re: Geotechnical Review – Rear Yard Lot Terracing
Proposed Residential Development – Conservancy Lands East
Borrisokane Road – Ottawa, Ontario

file: PG5036-MEMO.40

Paterson reviewed the following drawings prepared by DSEL as part of the current memorandum:

- No. 20-1180 – Grading Plan – Sheet No. 93 to 94, Revision 15, dated May 24, 2024.

FIGURE 4 - PROPOSED TERRACING PLAN - SECTION B-B

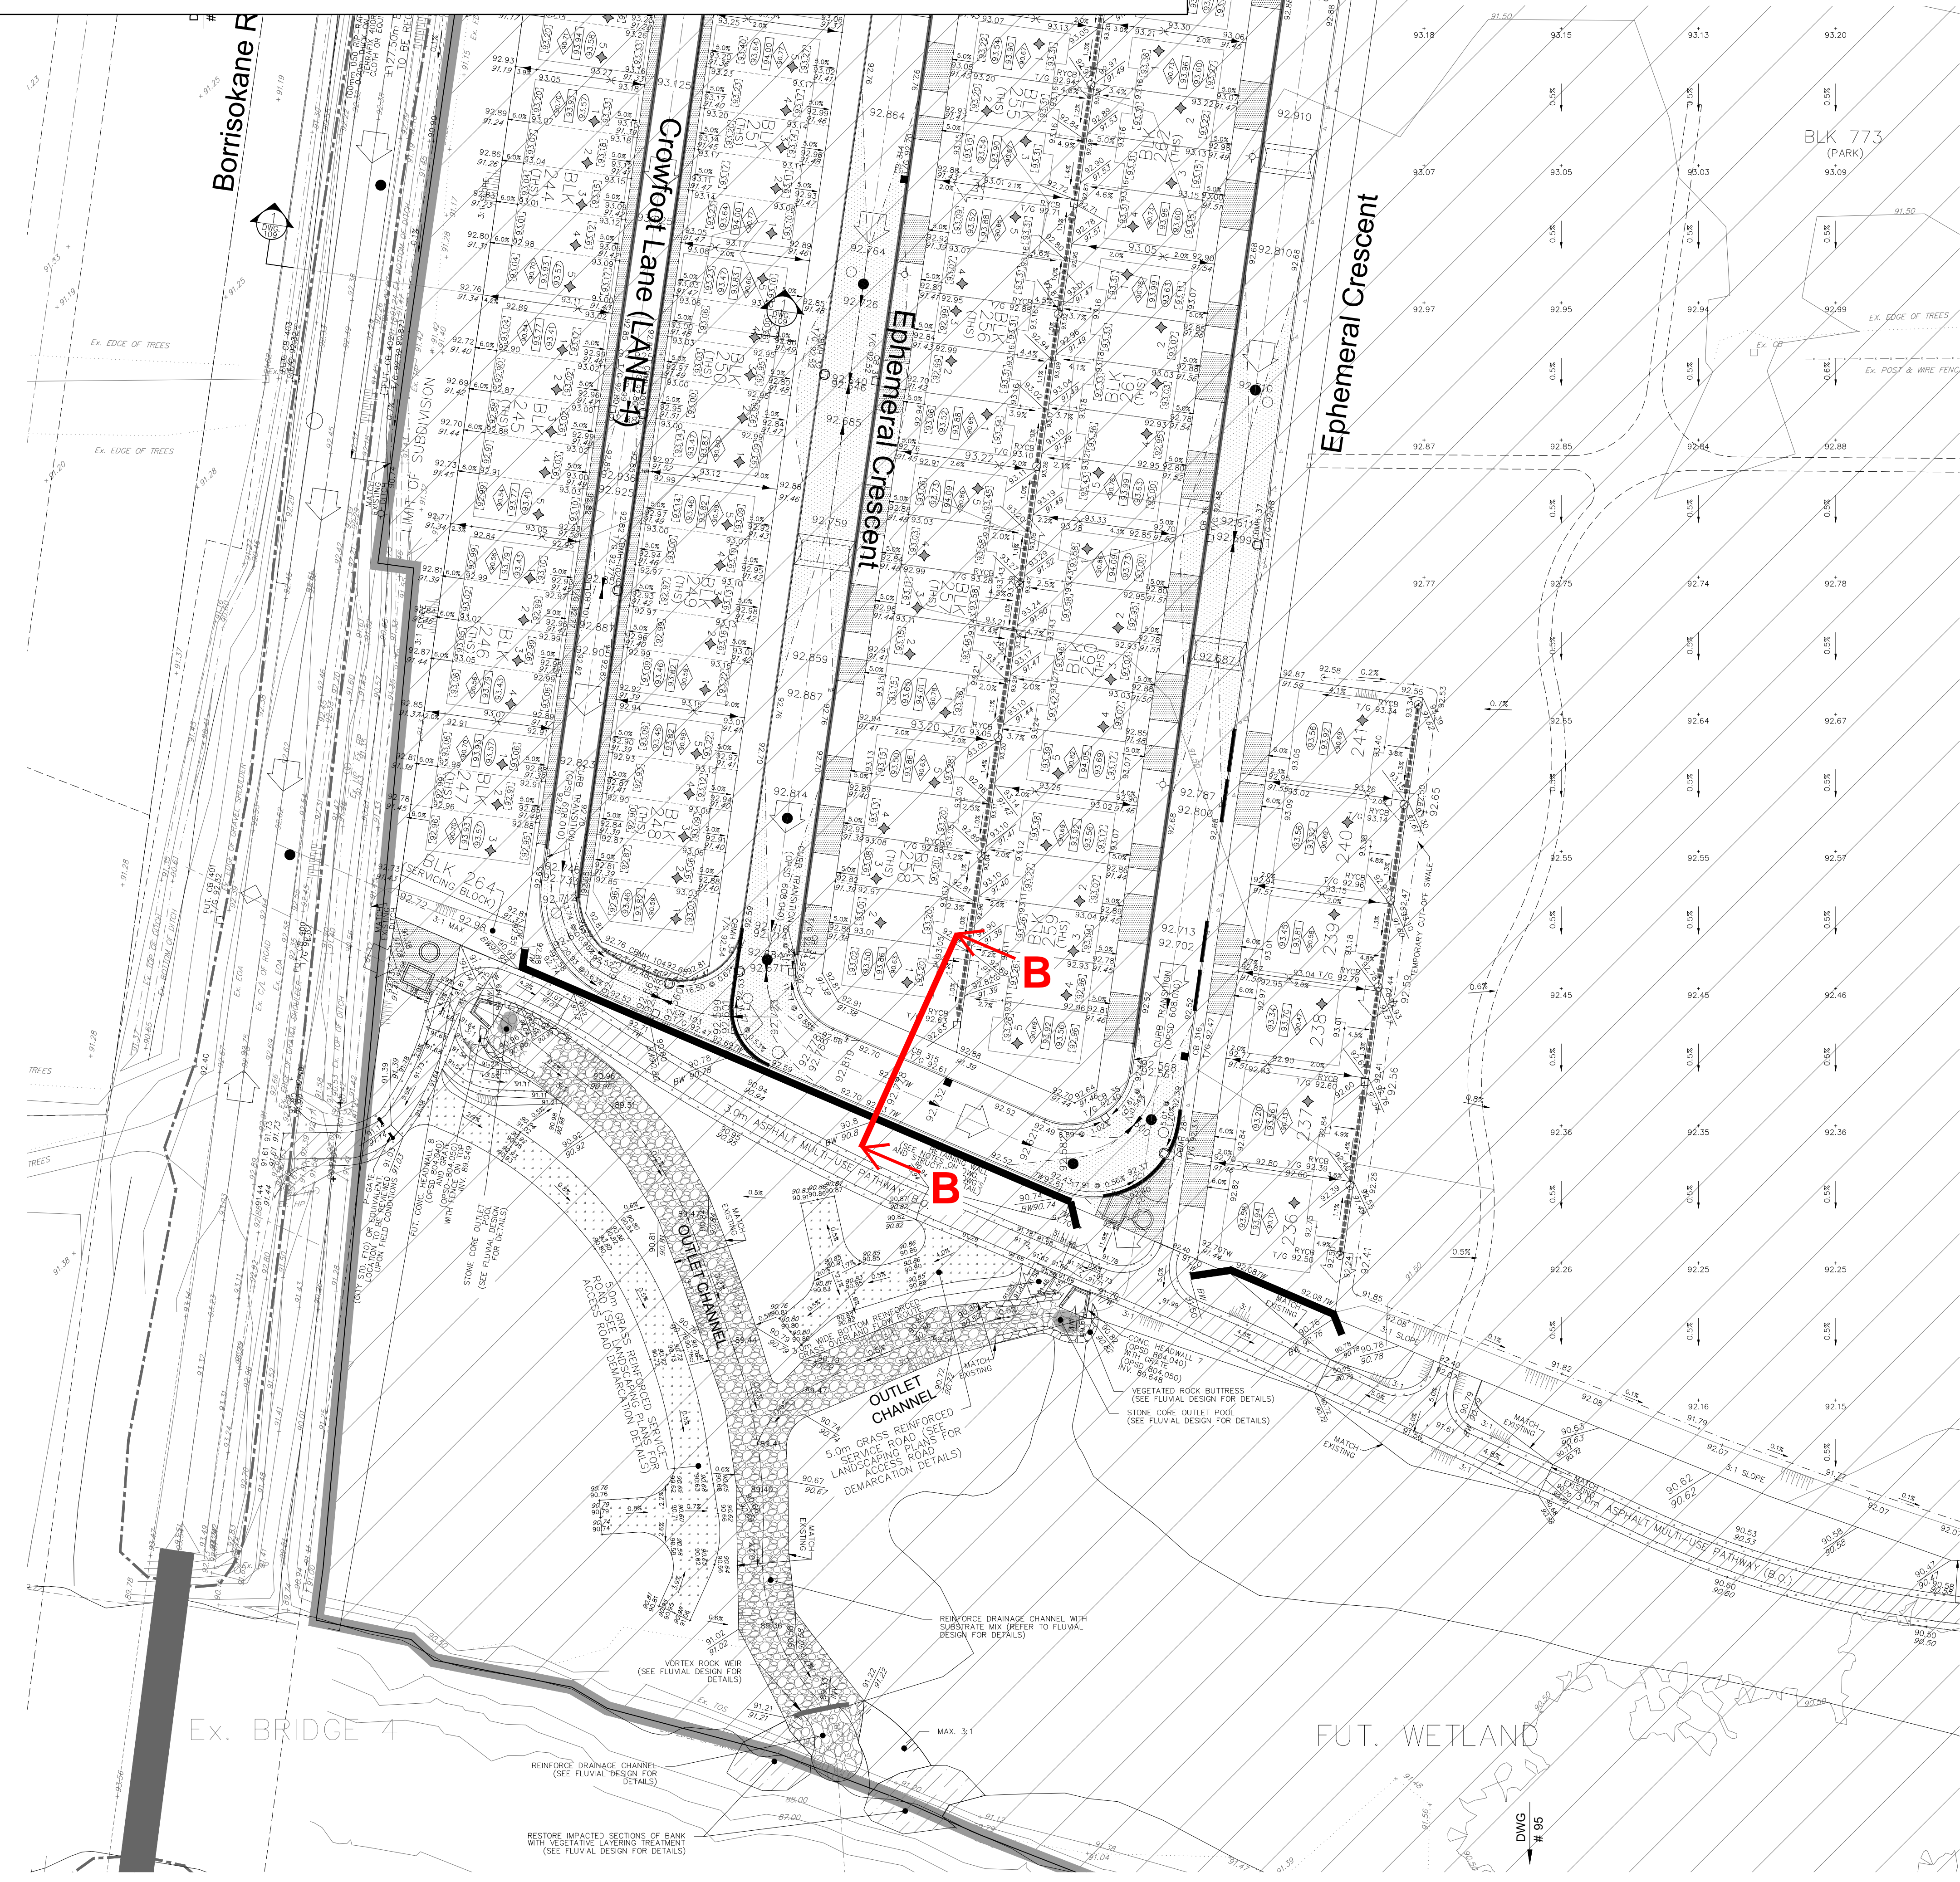
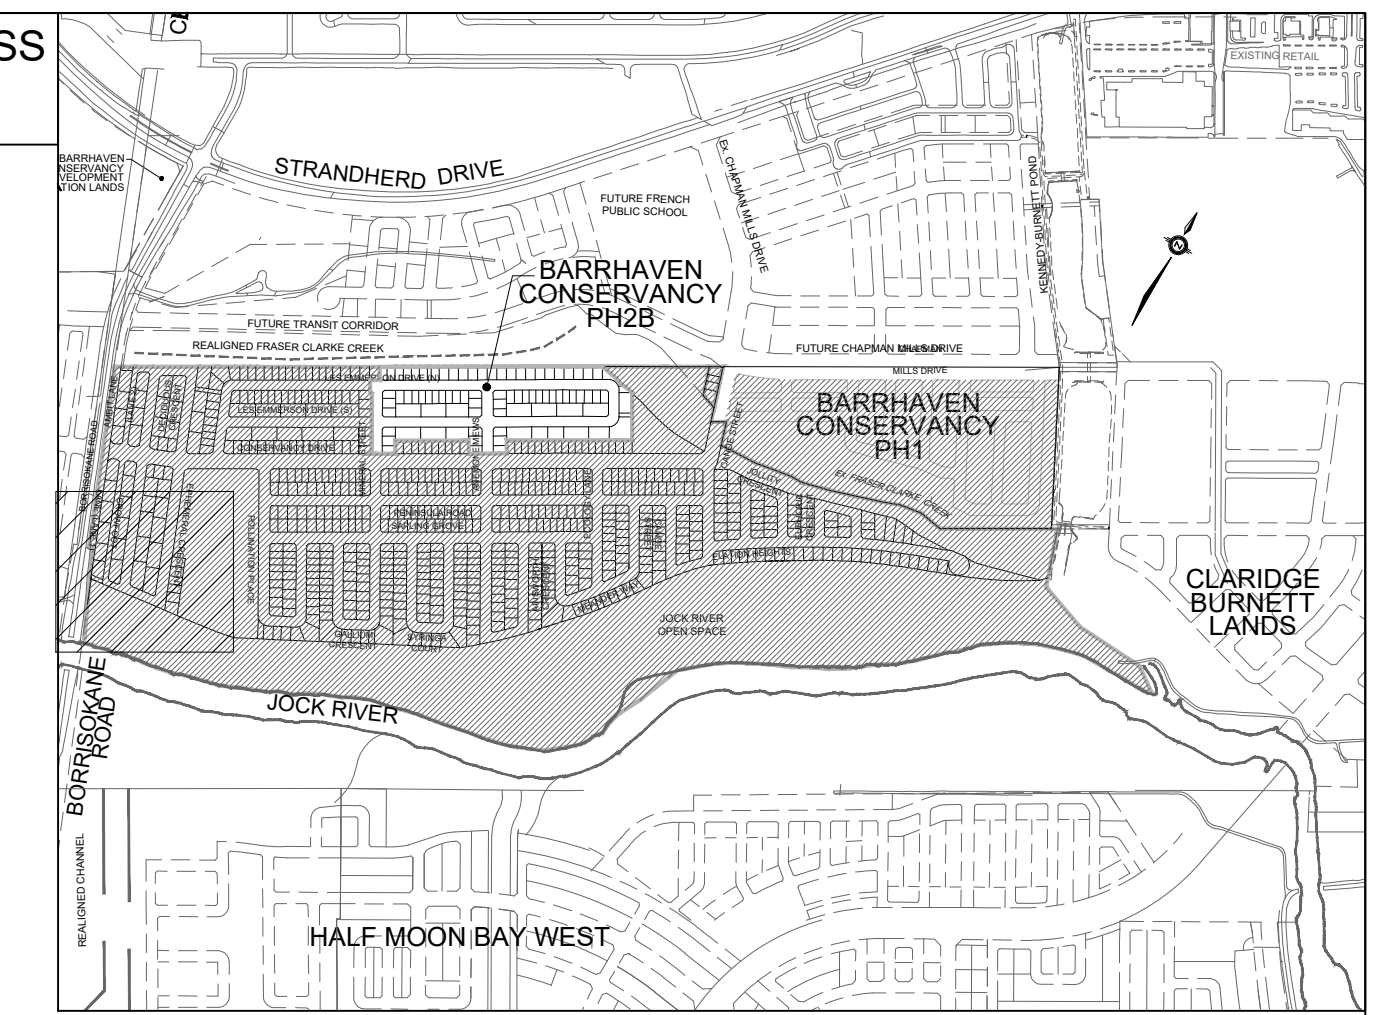
One (1) slope cross-section, representing a maximum 1.5H:1V, reinforced slope, was studied at each area in which terracing has been proposed. The cross-section locations (Sections A-A and B-B) are presented on Figure 3 and 4 – Proposed Terracing Plan.

The cross-sections were analyzed to determine if 1.5H:1V terracing could be supported at the subject site, taking into consideration proposed structures and the existing soil conditions.

The proposed terracing at the property boundaries is considered to be acceptable, from a geotechnical perspective. For permanent slopes with a 1.5H:1V slope profile, it is recommended that a nonwoven geotextile such as Terrafix 200r be placed over the engineered fill material located at the slope face, and beneath the topsoil and landscaping soils to promote long-term stability of the rear-yard slope face. The geotextile fabric should extend a minimum of 0.3 m beyond the top and toe of the slope face.

Further, an erosion control net, such as Fibramulch C32, or approved equivalent should be placed above the topsoil layer to prevent erosion of the slope while vegetation is established. The erosion control net should extend a minimum of 0.3 m beyond the top and the toe of the slope.

SLOPE SEEDING AND PLANTING

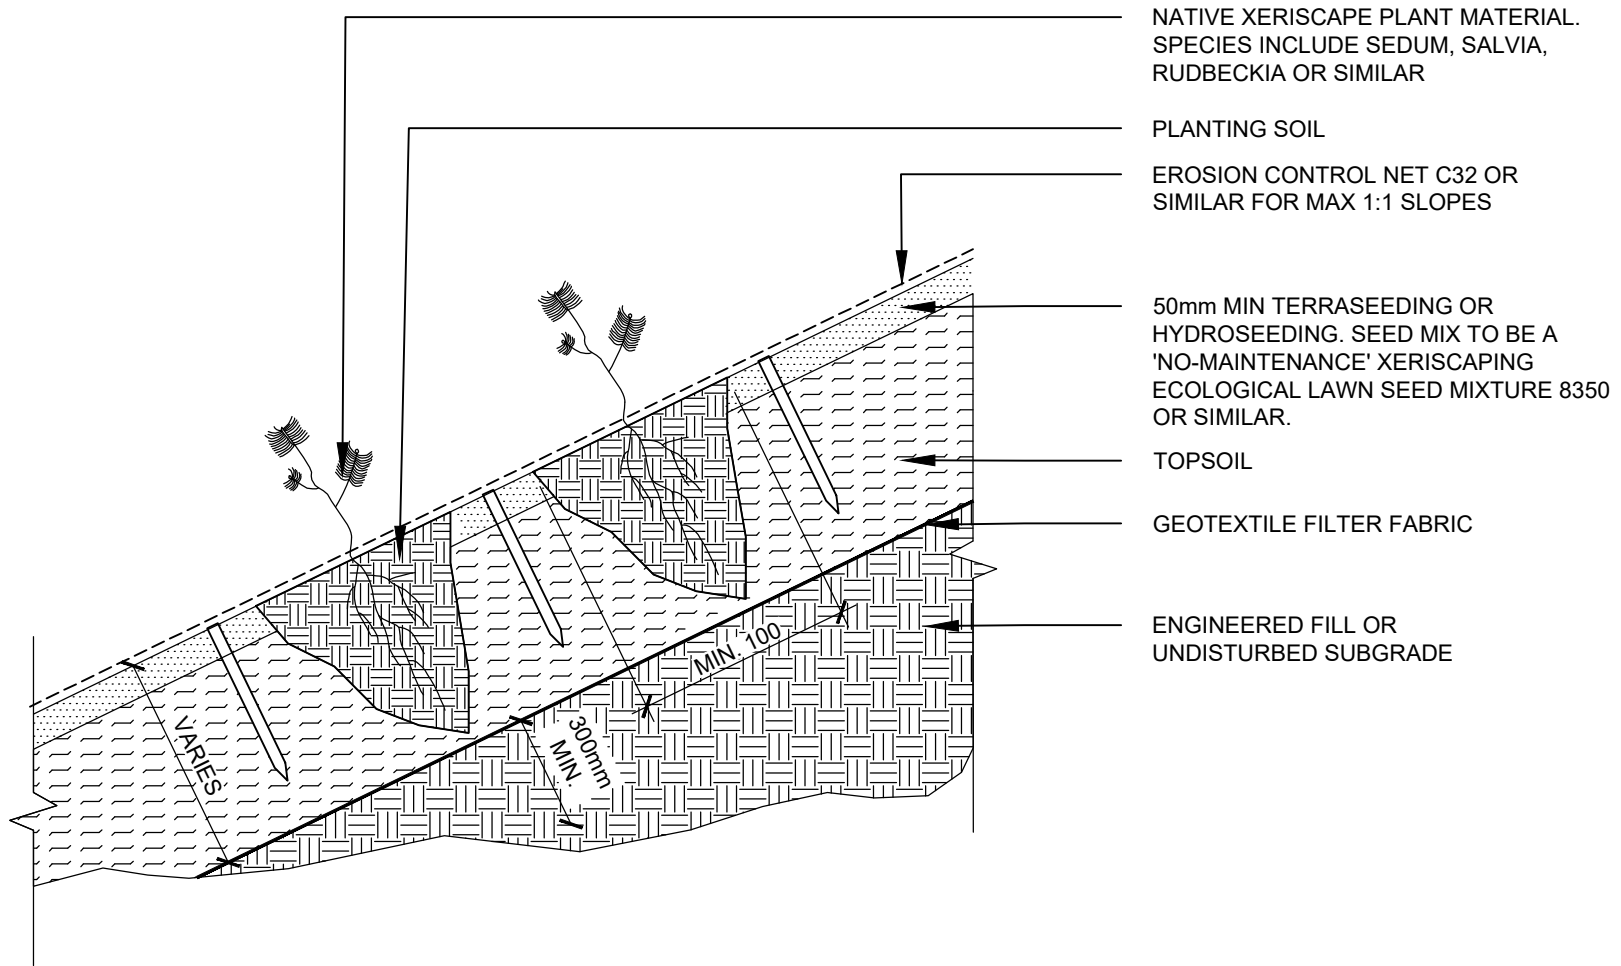
This slope planting detail is illustrated on the attached sketch, appended to the memorandum.

Vegetation growth along the slope should be promoted by carrying out hydroseeding or terraseeding along the slope face. Vegetation and tree planting along the slope face fill will further promote stability of the slope long-term through development of the root network.
